RE: Project No. 12611-003 – New York, Roosevelt Island Tidal Energy Project
Request for Additional Information on Draft Pilot License Application

ROOSEVELT ISLAND TIDAL ENERGY PROJECT
P-12611-003

**VERDANT POWER RESPONSE TO
REQUEST FOR ADDITIONAL INFORMATION ON
DRAFT PILOT LICENSE APPLICATION**

Figure 5.3.4.1-3. (revised) Bird distribution from observations.

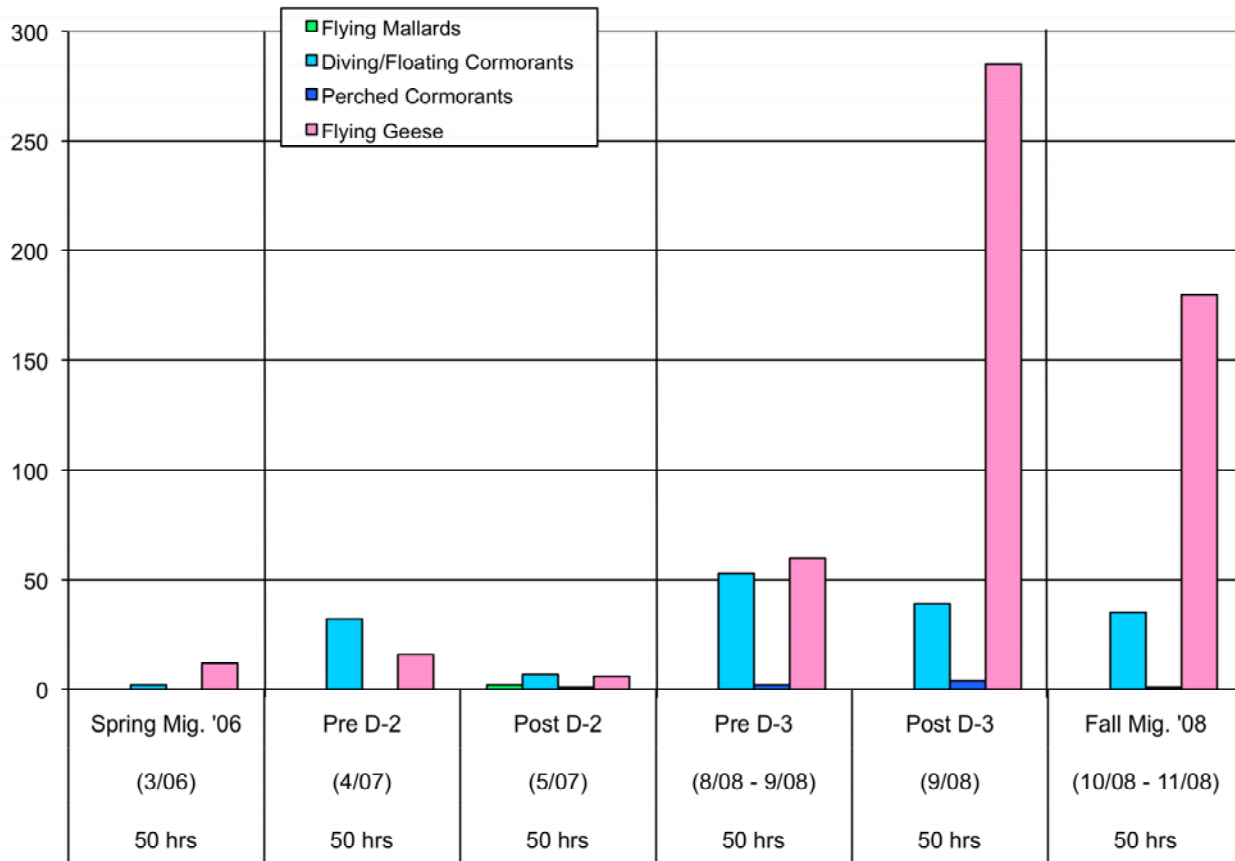
10(b). Page E-138, Table 5.3.4.1-2 summarizing the bird observation study, Figure 5.3.4.1-3 illustrating bird distribution from observations, and Table 5.3.4.1-3 listing species common to the New York region observed near the RITE demonstration project have conflicting data. In Table 5.3.4.1-2, it is unclear if the data represented in the column labeled “Canada Geese Total” is the total number of geese observed or if the data represents “flying geese” observed as indicated in Figure 5.3.4.1-3. Further, Post-D1 data listed in Table 5.3.4.1-2 should also be included in Figure 5.3.1.1-3. Table 5.3.4.1-3 notes that diving ducks were observed; however, diving ducks are not represented in Table 5.3.4.1-2 or Figure 5.3.4.1-3 nor is the species of the diving ducks indicated. All avian species observed and data recorded should be presented in these tables and figures for consistency, comparison, and evaluation purposes.

Verdant notes that on page E-138, Table 5.3.4.1-2, the “Canada Geese Total” is exactly equal to the total number of flying geese as shown in Figure 5.3.4.1-3 and the discrepancy was a typographic error on the table. These labels have been modified to match. Post deployment 1 (D1) data was removed from the data set because the number of hours observed were not equivalent to the other observations. The removal was missed in the table and has now been modified.

The diving ducks observed were mallard ducks and have been added to Table 5.3.4.1-2 and Figure 5.3.4.1-2. The species is now also listed in Figure 5.3.4.1-3. Figures 5.3.4.1-a and 5.3.4.1-b show the RITE Demonstration Project bird data by month, unlike the figures in the Draft License Application. Figure 5.3.4.1-b has normalized data over 5 hours for direct comparison between months.

Figure 5.3.2.3-1. Location of video surveys

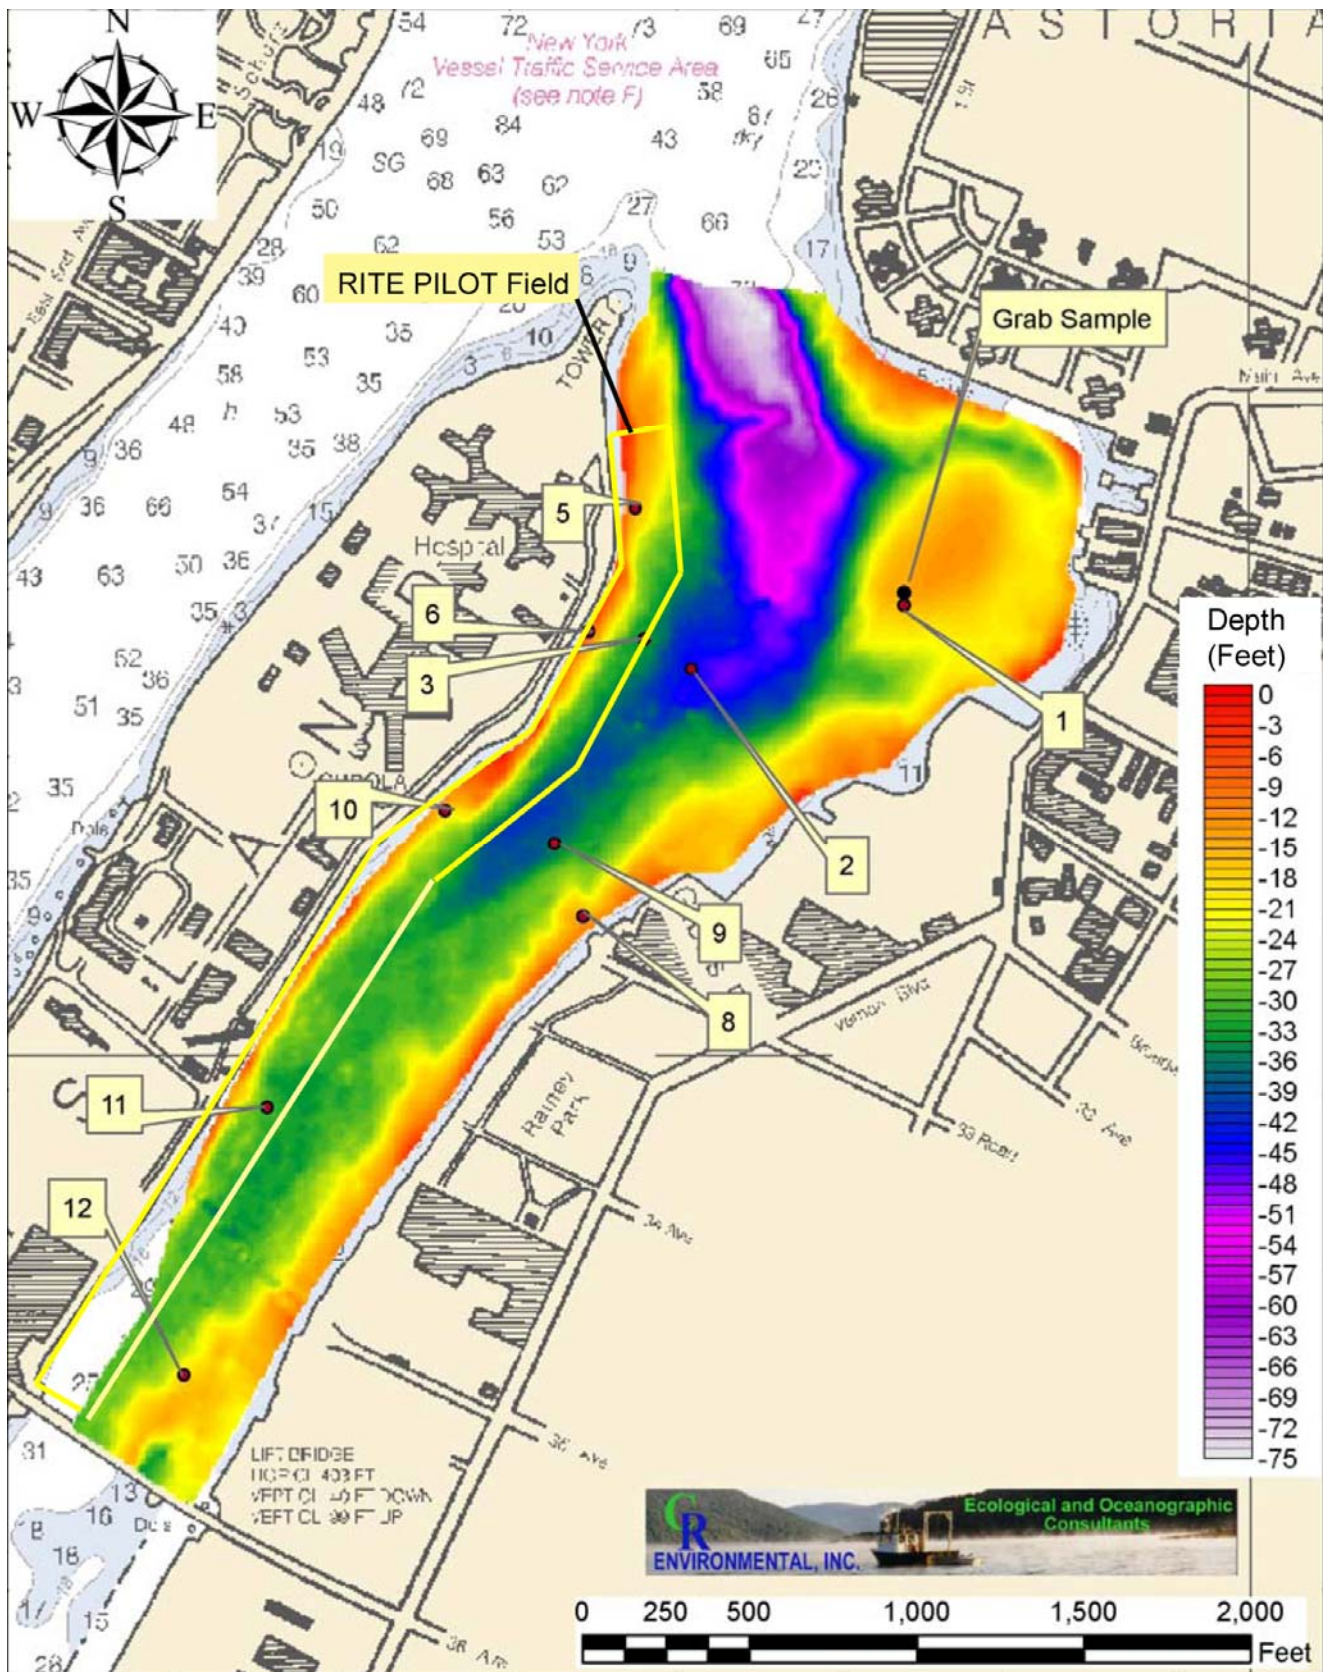
8(e). Page E-78, figure 5.3.2.3-1 shows the location of the video surveys used to locate and collect fine sediments. The numeric values on the x-axis, y-axis, labels, and legend are illegible, as are the notes below the map. It is also not clear what the values associated with the axes and color legend represent. In order to adequately interpret the results of the sediment survey, please provide a clearer copy of the figure with the axes and legend appropriately labeled.

Verdant acknowledges that Figure 5.3.2.3-1, “Location of video surveys” on page E-78 lacks visual clarity, particularly in the printed document.

Verdant has made the following changes and resubmit the Figure as attached:

- Removed numeric values on x- and y- axes (used solely for GIS mapping)
- Clarified color legend labels
- Added RITE Pilot Project boundary indications
